CONTRACT CHANGE ORDER

CCO 106	Suppl. No. 1	Contract No. 04 - 0120F4	Road SF-80-13.2/13.9	FED. AID LOC.:

CCO DESCRIPTION:
Skyway OBG Lowering near Hinge A

PROJECT DESCRIPTION:
CONSTRUCT SELF-ANCHORED SUSPENSION BRIDGE

SKYWAY OBG LOWERING NEAR HINGE A NO. 1

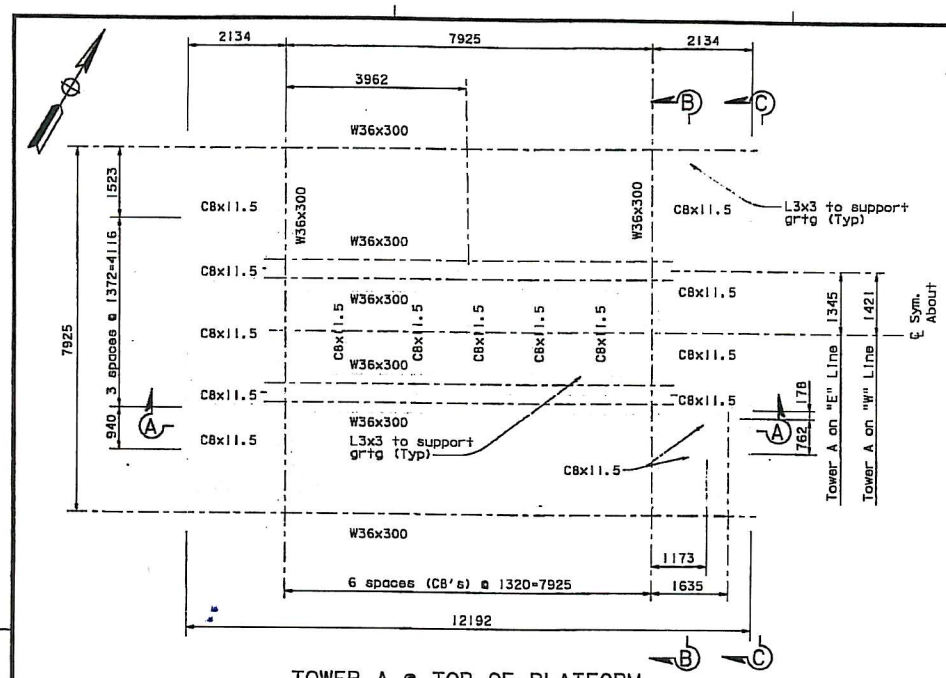
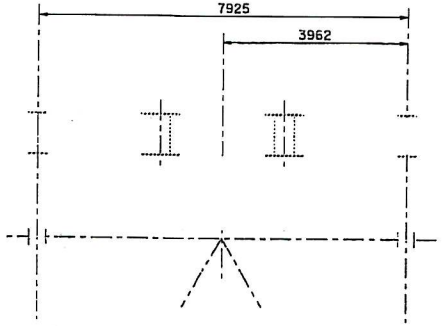
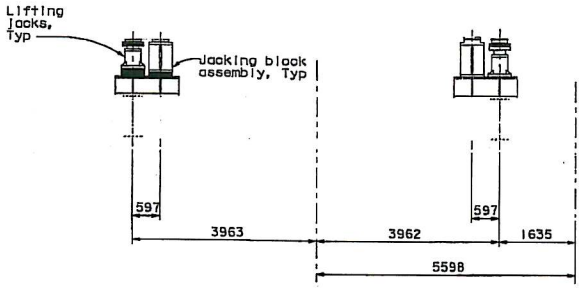
1. Westbound shown; Eastbound similar.
2. All dimensions are approximate and shall be verified in the field.
3. All steel shall be ASTM A36 or better unless otherwise approved by the Engineer.

SKYWAY OBG LOWERING NEAR HINGE A NO. 2

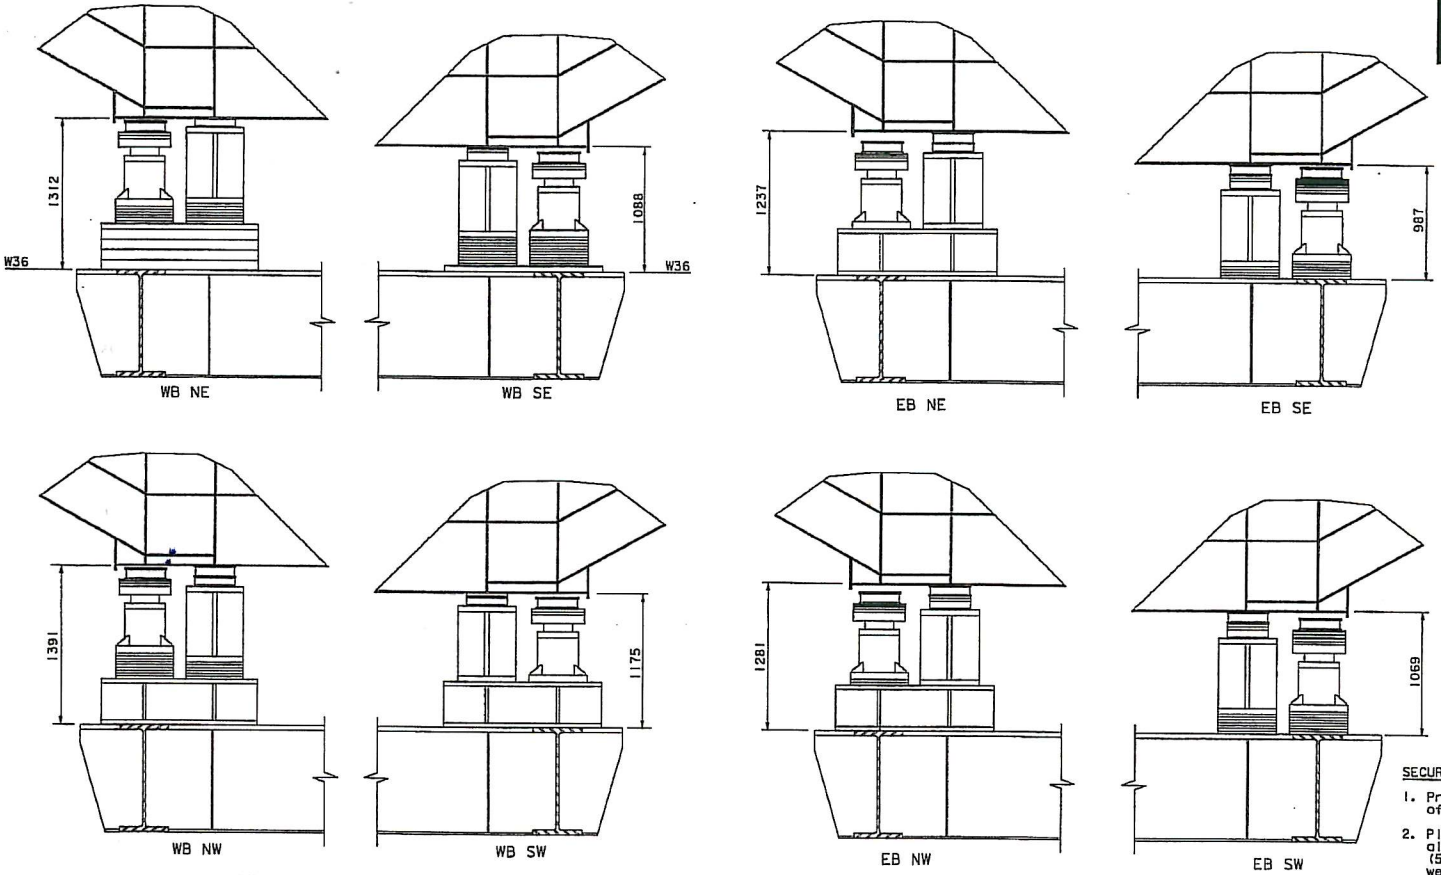
SECURING OF TRANSITION STRUCTURES VERTICALLY:

1. Prior to performing any work, determine the location of the longitudinal web plates and mark deck plate.
2. Place timber cribbing and locate concrete weights along the two web plates above jack locations (50 Tonnes total, each WB & EB). For concrete weight placing limits, see "Skyway OBG Lowering Near Hinge A No. 6" sheet.
3. Remove any miscellaneous items that may interfere with lowering operation, i.e. handrails, etc.

SURVEY OF AS-BUILT TRANSITION STRUCTURES PRIOR TO THE LOWERING OPERATION:

1. Survey, record and provide the Engineer the existing position (longitudinal, transverse and vertical) at the locations indicated on "Skyway OBG Lowering Near Hinge A No. 6" sheet.
2. Survey, summarize, record and provide the Engineer both longitudinal and cross slope of the Transition Structure.
3. Provide elevations and coordinates in the State Grid System for all surveyed points.

SKYWAY OBG LOWERING NEAR HINGE A NO.3

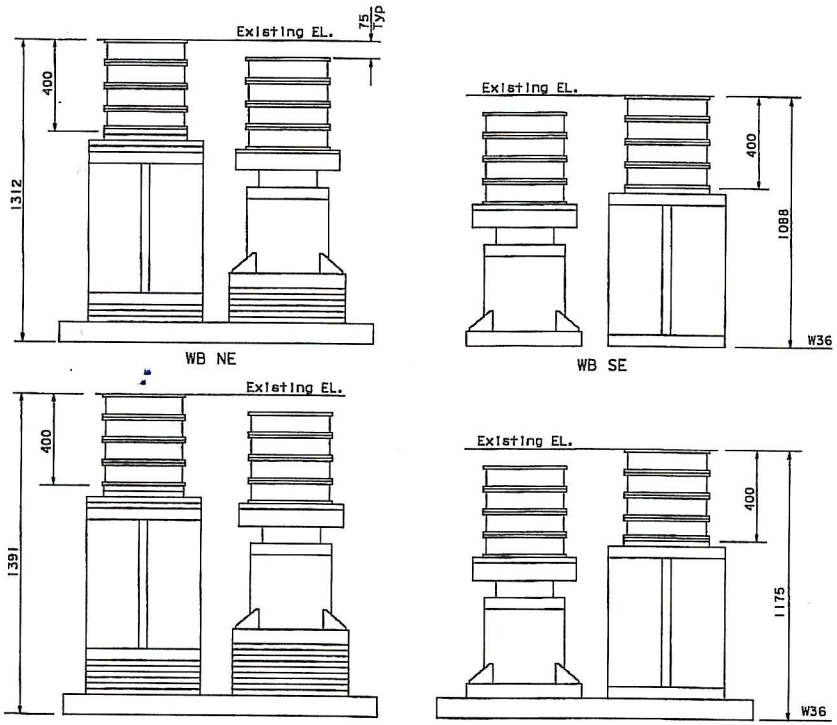
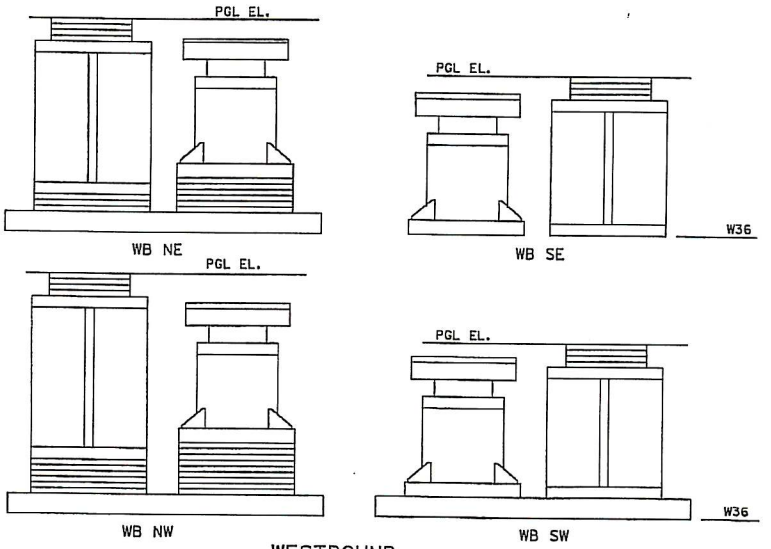
MODIFICATION OF EXISTING SUPPORTS:

1. Secure the Hinge A Pipe Beams against lateral and longitudinal movement.
2. Activate three jacks and raise Transition Structure by 25 mm.
3. Switch out and reconfigure the jack and shim stack at the fourth location. Activate lock rings on the jack when re-configuring the support.
4. Lower the box girder back on the shim stacks.
5. Raise the fourth jack and lower one of the other three (not diagonal).
6. Repeat Steps (2) to (5) at the remaining locations. Do not re-configure a support diagonal from the previously completed.
7. The OBG (location Northing, Easting and Elevation) shall be surveyed at each jacking step and recorded.
8. The jack loads shall be recorded at each jacking step.

Lowering Procedure:

1. Jack the Transition Structure up by 25 mm clear of the shim packs, using the four jacks, pressurized equally; note the pressure at which each jack "lifts-off" the corresponding shim pack. Record the "lift-off" pressure in the jacks.
2. Remove one 100 mm support pan at each support.
3. Lower the Transition Structure very slowly, avoiding any impact, and set down onto supports. Resurvey the Transition Structure (at the locations indicated on "Skyway OBG Lowering Near Hinge A No.6" sheet) to determine elevations, longitudinal and cross slopes.
4. Compress jacks and remove one 100 mm jack pan at each jack.
5. Repeat Steps 1 thru 4 until Transition Structure is at PGL.

SKYWAY OBG LOWERING NEAR HINGE A NO. 4

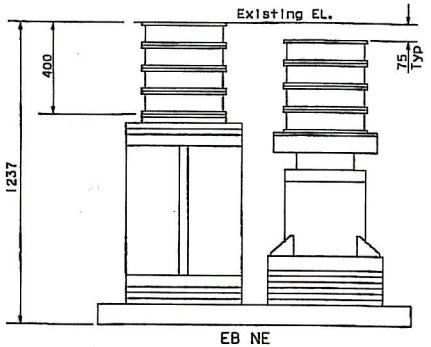
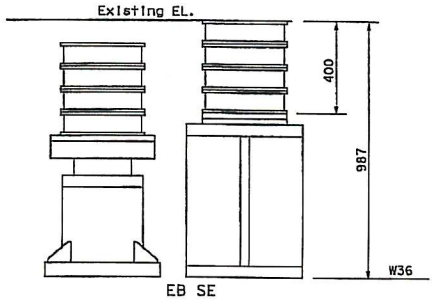
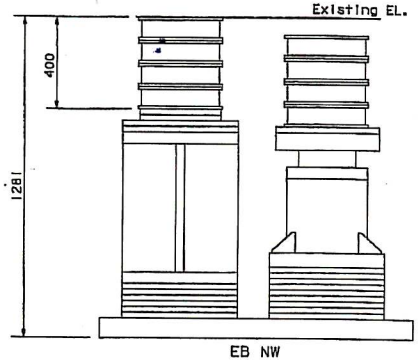
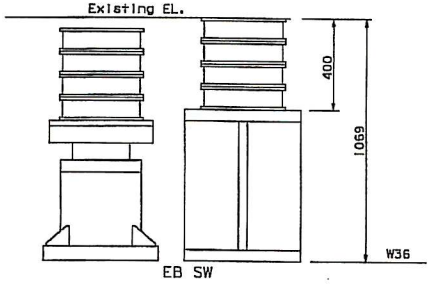
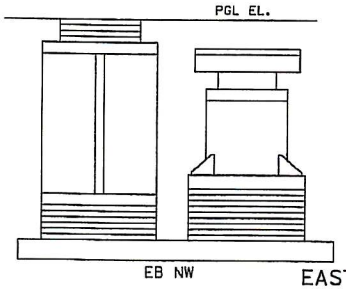
MODIFICATION OF EXISTING SUPPORTS:

1. Secure the Hinge A Pipe Beams against lateral and longitudinal movement.
2. Activate three jacks and raise Transition Structure by 25 mm.
3. Switch out and reconfigure the jack and shim stack at the fourth location. Activate lock rings on the jack when re-configuring the support.
4. Lower the box girder back on the shim stacks.
5. Raise the fourth jack and lower one of the other three (not diagonal).
6. Repeat Steps (2) to (5) at the remaining locations. Do not re-configure a support diagonal from the previously completed.
7. The OBG (location Northing, Easting and Elevation) shall be surveyed at each jacking step and recorded.
8. The jack loads shall be recorded at each jacking step.

Lowering Procedure:

1. Jack the Transition Structure up by 25 mm clear of the shim packs, using the four jacks, pressurized equally; note the pressure at which each jack "lifts-off" the corresponding shim pack. Record the "lift-off" pressure in the jacks.
2. Remove one 100 mm support pan at each support.
3. Lower the Transition Structure very slowly, avoiding any impact, and set down onto supports. Resurvey the Transition Structure (at the locations indicated on "Skyway OBG Lowering Near Hinge A No.6" sheet) to determine elevations, longitudinal and cross slopes.
4. Compress jacks and remove one 100 mm jack pan at each jack.
5. Repeat Steps 1 thru 4 until Transition Structure is at PGL.

1. All dimensions are approximate and shall be verified in the field.
2. To the extent possible, remove all equipment on the span at the time of the jacking operation, including trucks or other vehicles, construction materials, containers, etc. Note the presence or absence of railings, bike path, barriers, wearing surface, utilities, etc. Note the position of the secured pipe beams. Provide the Engineer with the location and magnitude of any such loads that cannot be removed.
3. The survey and jacking shall be completed before dawn, when structures are at uniform ambient temperature. Note the ambient and gradient temperatures in the Transition Structures when the lowering operations are performed. Note the wind speed.
4. An existing beam may be cut and re-welded to become a 400 mm beam. Alternatively, an existing W16 beam may be used.

SHEAR KEY MODIFICATIONS

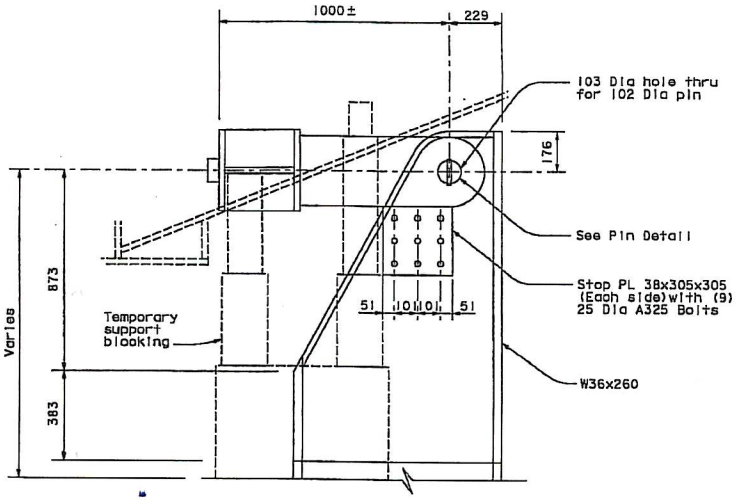
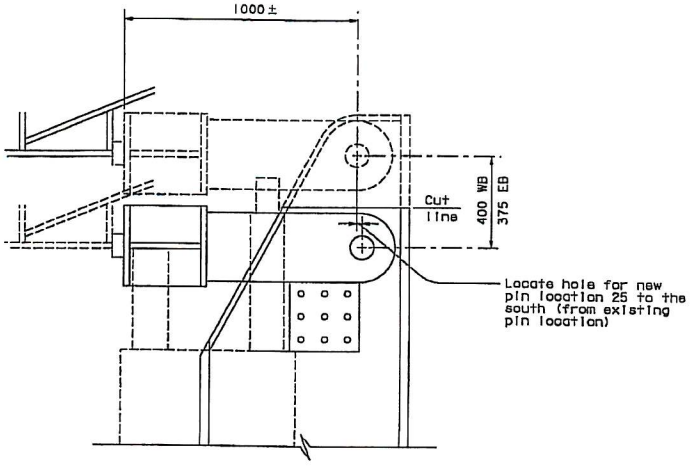
RETROFIT EXISTING SHEAR KEY PROCEDURE:

1. The shear key shall be modified immediately prior to lowering.
2. Temporarily support horizontal brace on blocking and remove stop plates.
3. Drill new 103 Dia hole at location shown.
4. Drill new holes for stop plate bolts.
5. Re-install stop plates at new location.
6. Lower horizontal brace to new location and install 102 Dia pin.
7. Cut-off upper section of existing shear key as shown.
8. OBG may now be lowered.

SKYWAY OBG LOWERING NEAR HINGE A NO. 6

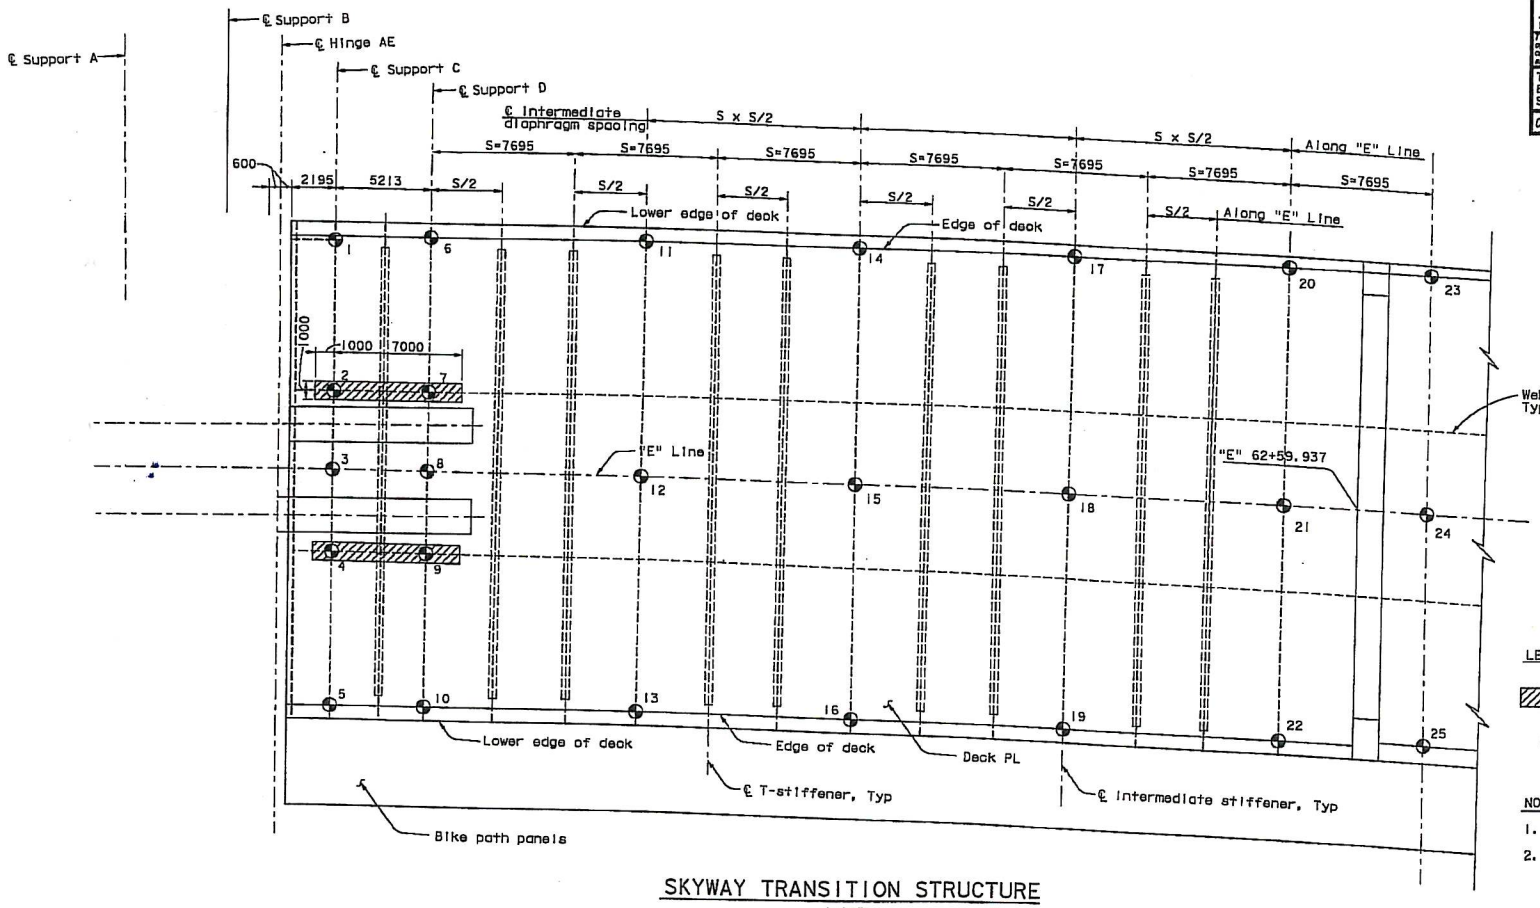
Concrete weight placing limits

Survey Point
